FORD E4OD "UPDATE HANDBOOK"

*Updated
April, 2004*

VALVE BODY, SPACER PLATE, SPACER PLATE GASKETS, CHECKBALL LOCATIONS, AND CASE CHANGES, FOR THE 1996 MODEL YEAR

Figure 55

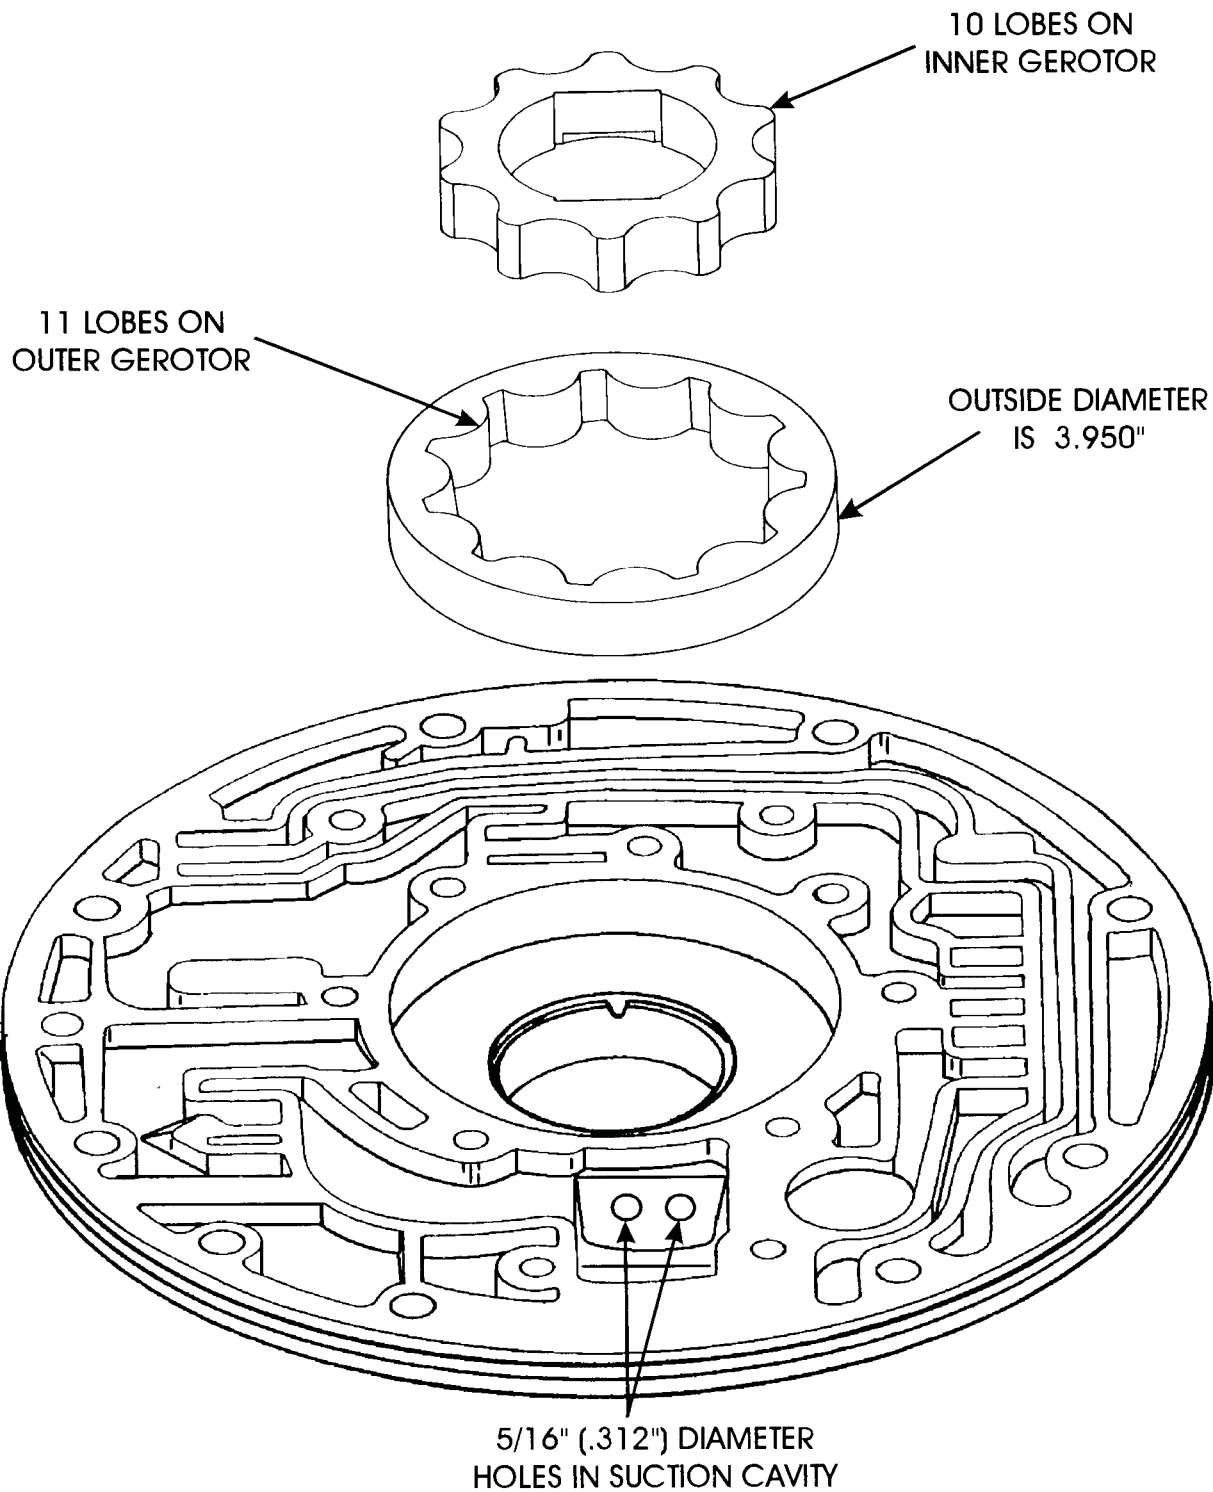
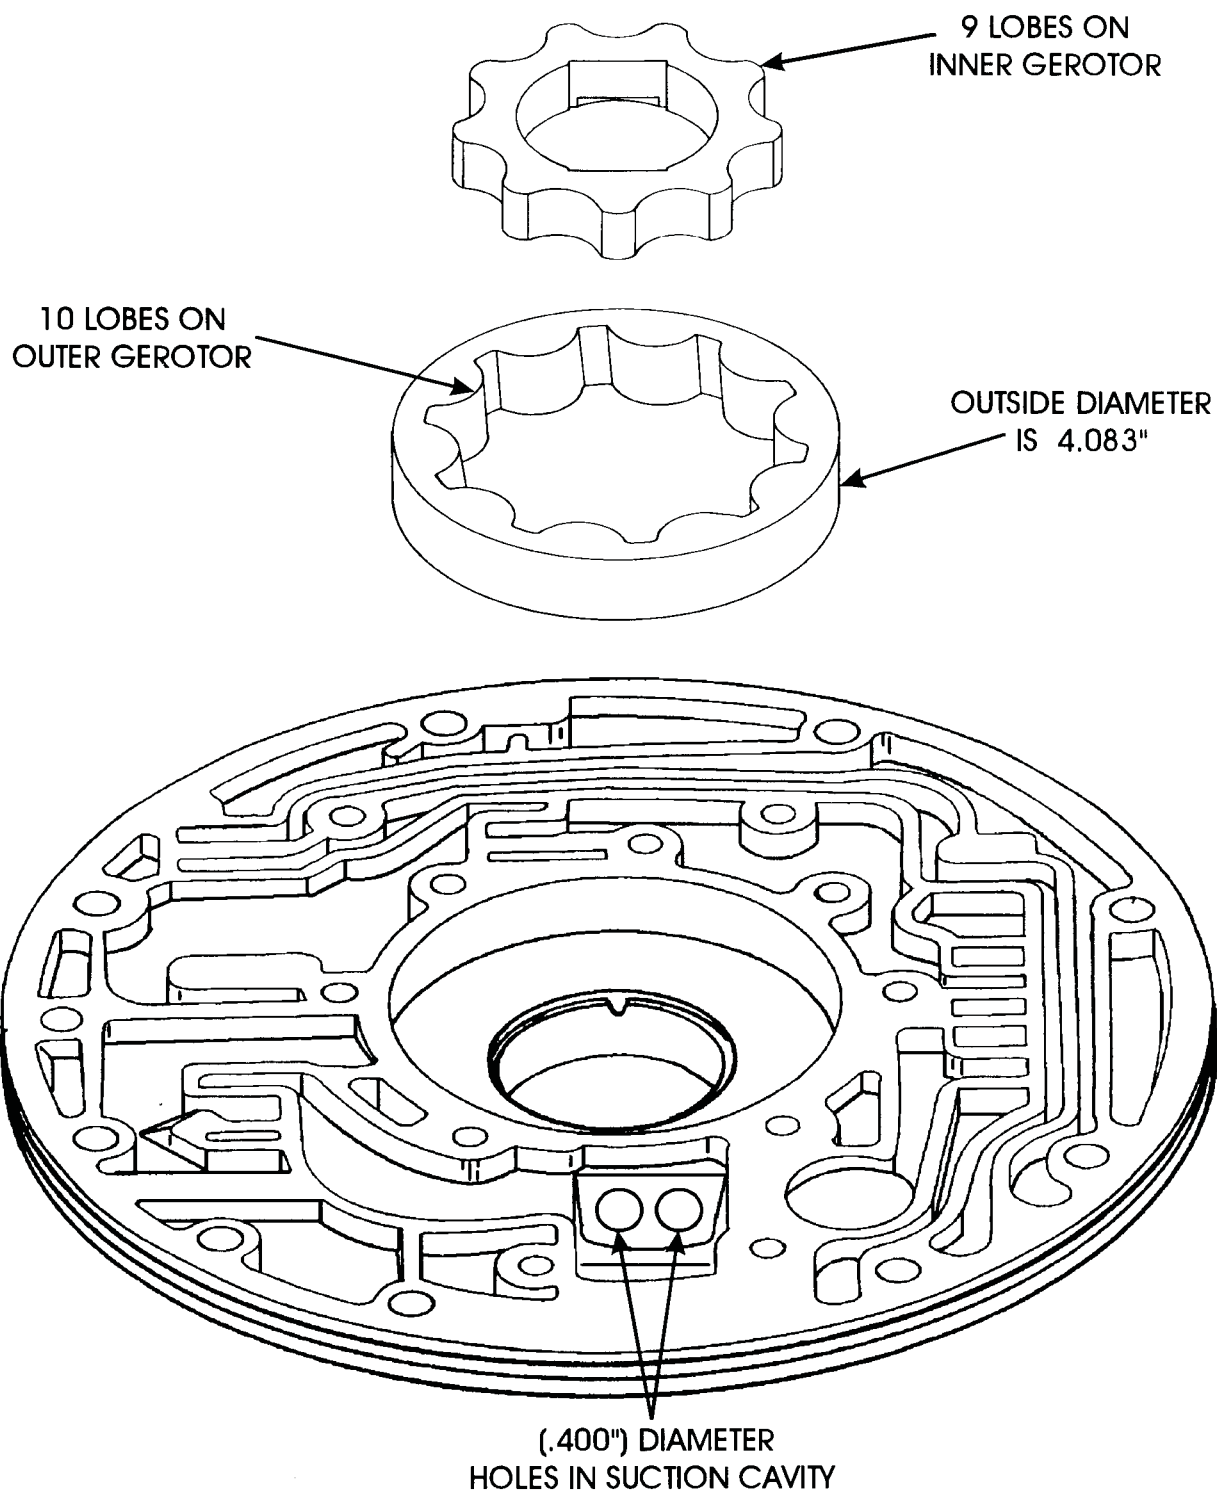
- (3) **INNER GEROTOR** - The lobes on the Inner Gerotor changed from the previous 10 lobes to 9 lobes on the new design, to accommodate the changes on the outer gerotor. Refer to Figures 55 and 56. The changes on both the inner and outer gerotor increased the cavity between the gerotors for increased pump volume, as shown in Figure 57.

Figure 59

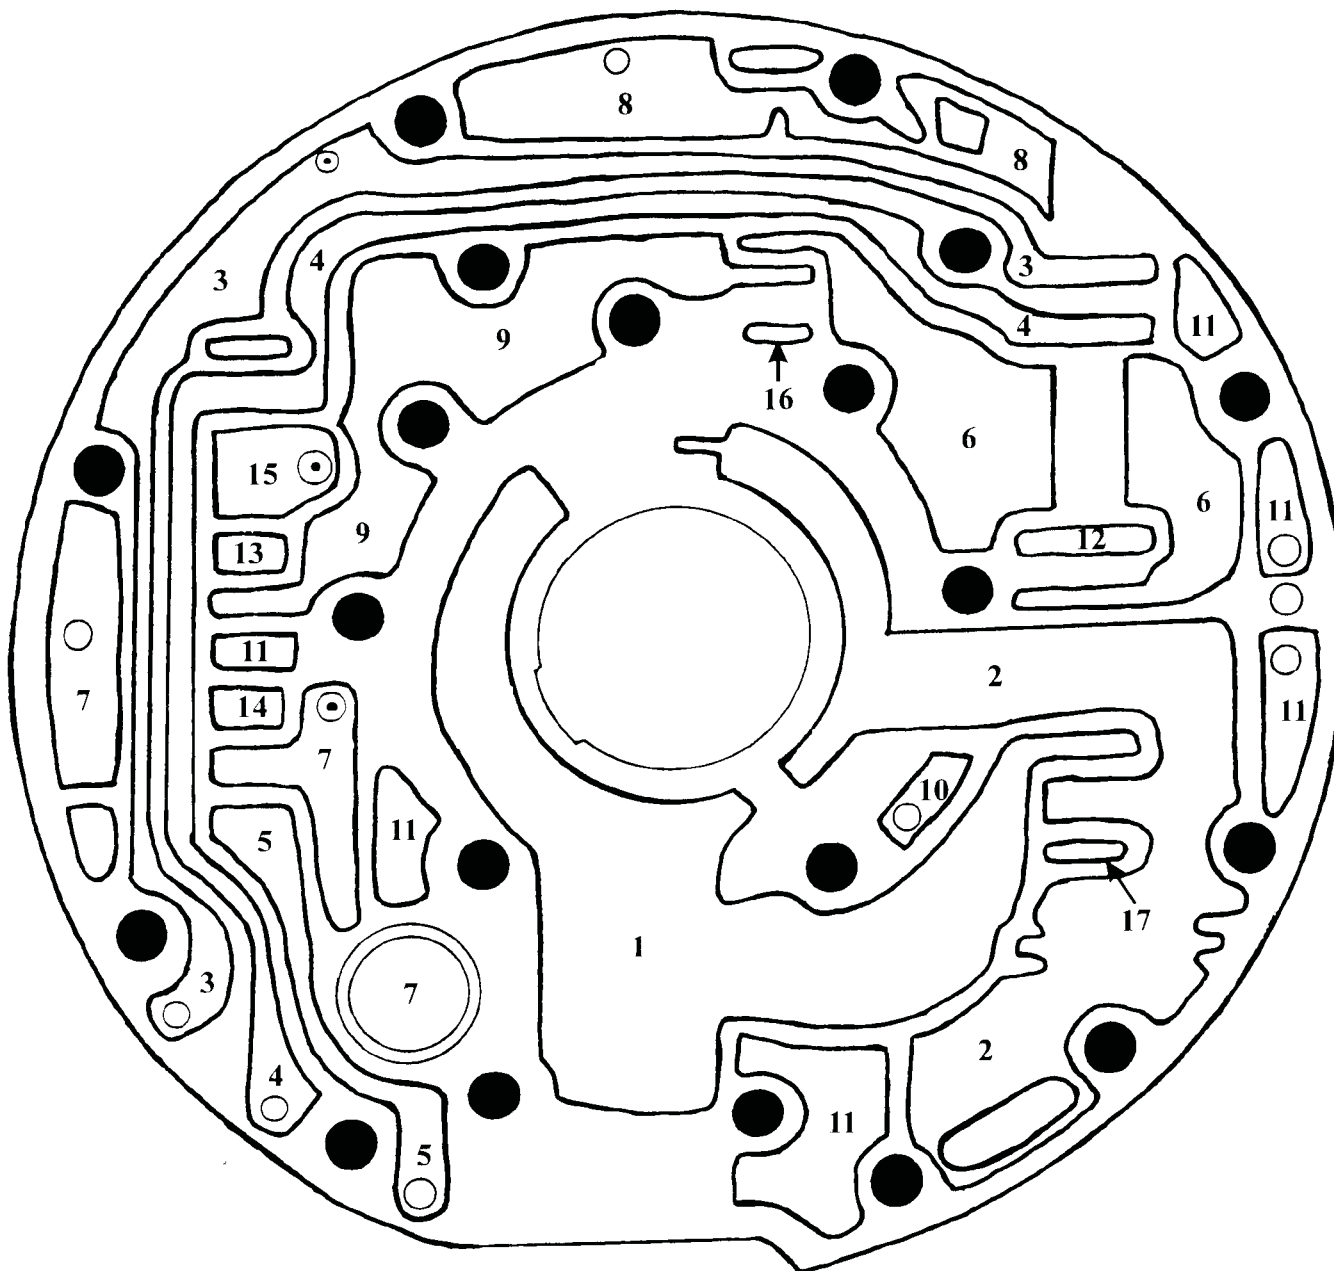
- (4) **FRONT PUMP COVER** - Received casting changes with added ribs in strategic places to increase torque retention when the two halves are torqued properly. The Pump Body to Pump Cover bolts should be torqued to 18-23 ft.lbs, with the alignment ring in place.
The easiest way to identify the new design level Pump Cover is with the "Rough Forging Number" F5TP-7B324-AA, and is located on the back side of the Pump Cover.
All of the oil passages in the new design Pump Cover remained the same as previous years and are identified in Figure 59. Internal pump cover passages are identified in Figure 60.

Figure 61

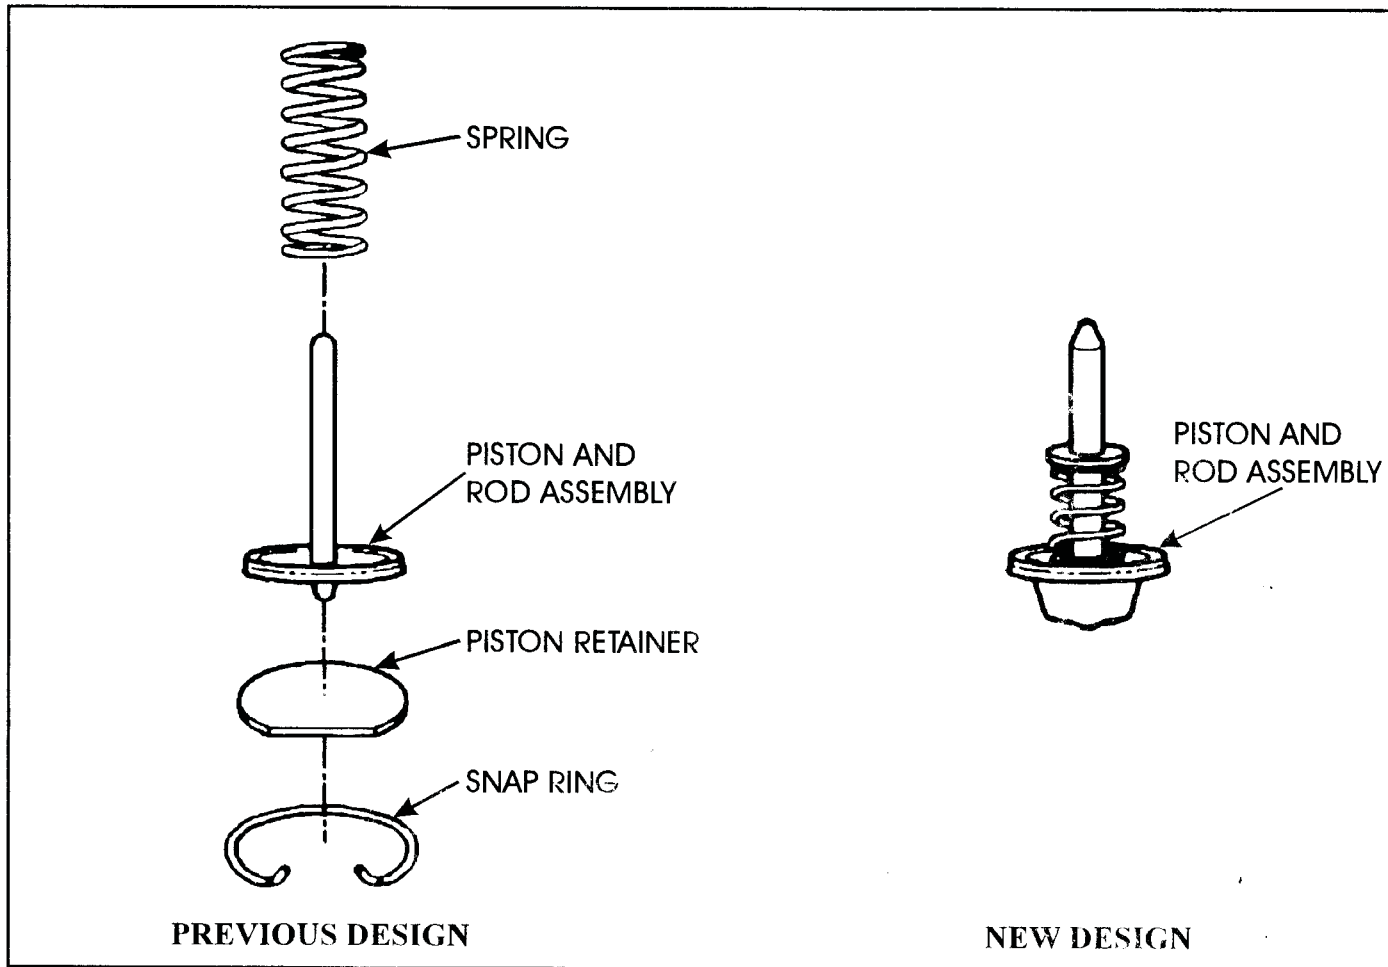
- (1) INTERMEDIATE SERVO PISTON - Total change in design, as shown in Figure 61.
- (2) SERVO PISTON RETAINER - Eliminated, as shown in Figure 61.
- (3) RETAINING SNAP RING - Eliminated, as shown in Figure 61.
- (4) TRANSMISSION CASE - Snap ring groove in the case piston bore was eliminated, as it was no longer need (See Figure 62).

Figure 63

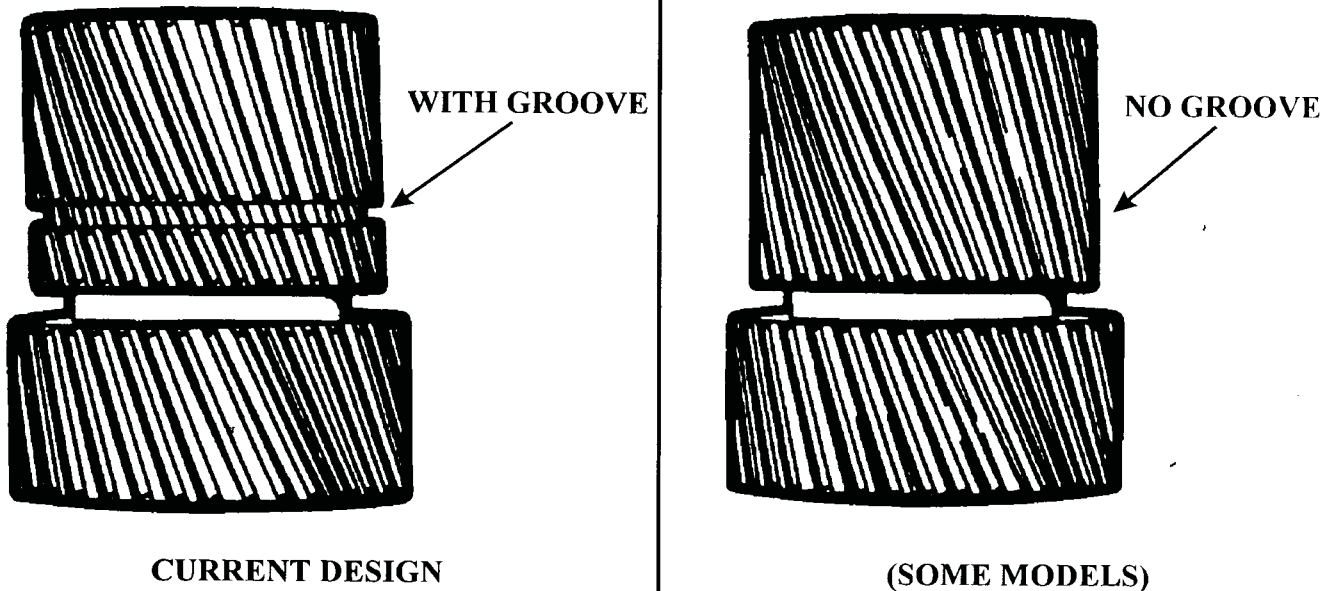
Some models of the E4OD transmission have been built with a Forward/Reverse Sun Gear that does not require a retaining snap ring, and has no groove for a snap ring, as shown in Figure 63. These transmissions are identified as model PRA-FA 12, serial number 00157935 thru 00158019. If internal transmission repair is required for these units, replace the Forward/Reverse Sun Gear with the current service sun gear with the snap ring groove, and the snap ring (See Figure 63).

***DO NOT REUSE THE FORWARD/REVERSE SUN GEAR
IF THE SUN GEAR HAS NO SNAP RING GROOVE.***

Figure 68

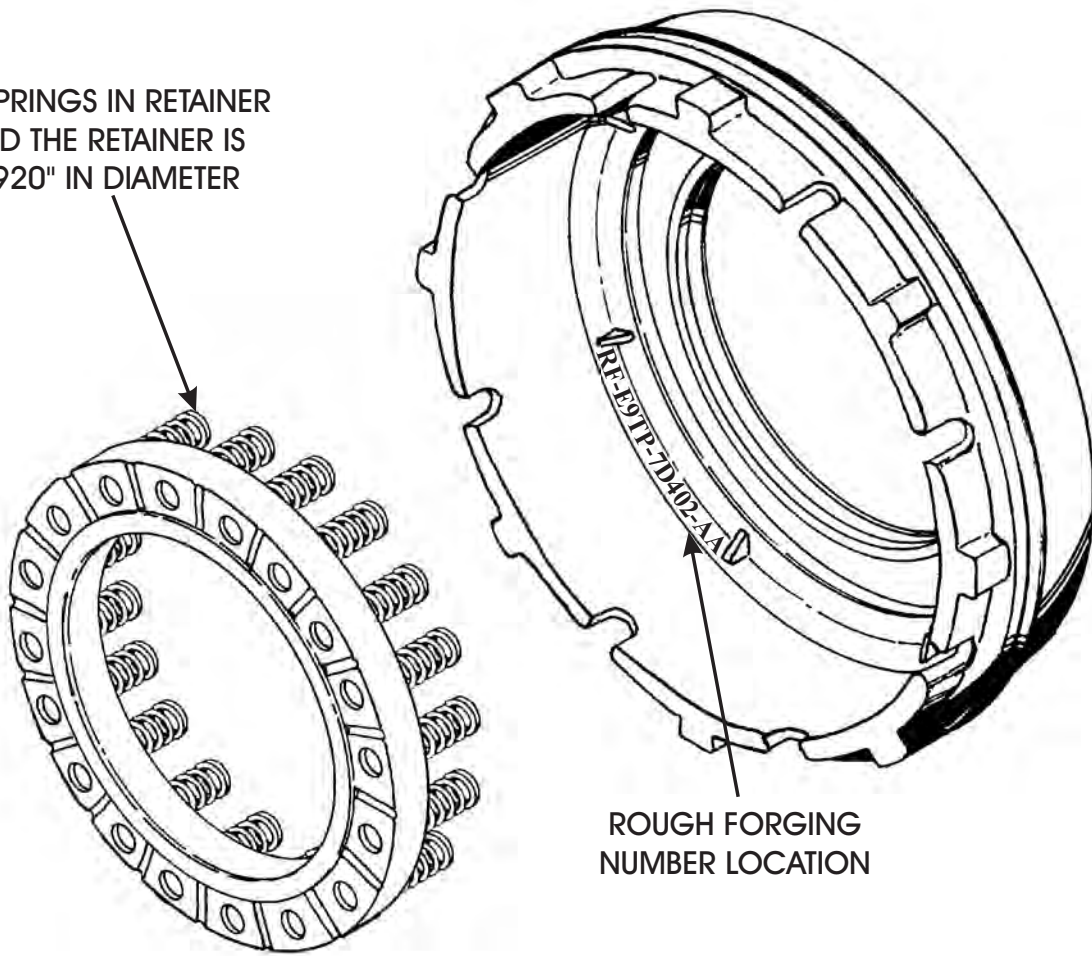
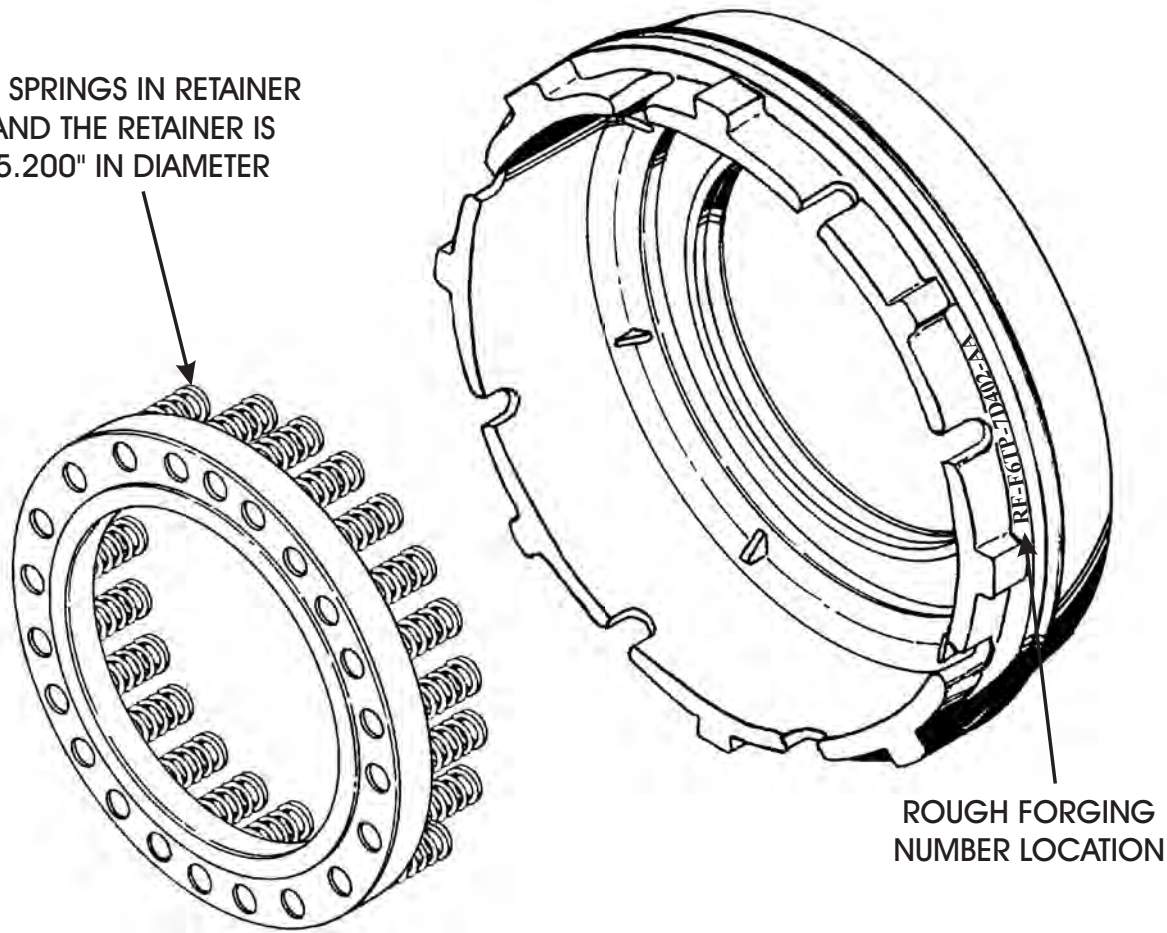
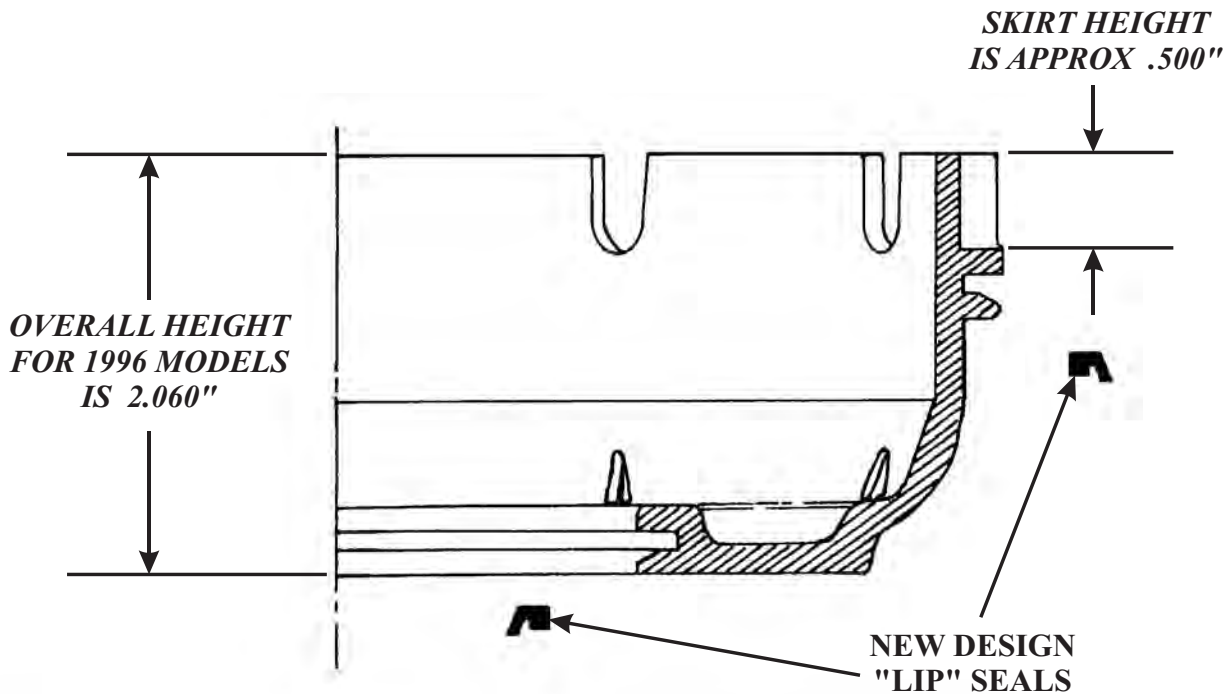
- (1) REVERSE CLUTCH PISTON SEALS - Change from the previous "Square" cut seals to the new design "Lip" seals, for increased sealing ability. Refer to Figures 68, 69 and 70.

- (2) REVERSE PISTON - Seal grooves in the piston are machined differently to accommodate the new design lip seals. The reverse piston skirt is also .140" shorter than the previous piston, to accommodate the added cushion (Wave) plate in the reverse clutch pack. This will obviously also affect the overall height of the piston. Refer to Figures 68, 69 and 70.
The pistons can be identified by the "Rough Forging" number, as shown in Figures 68 and 69.
Rough Forging Number RF-E9TP-7D402-AA = 89-95 Model (Square Cut Seals)
Rough Forging Number RF-F6TP-7D402-AA = 1996 Model (Lip Seals)
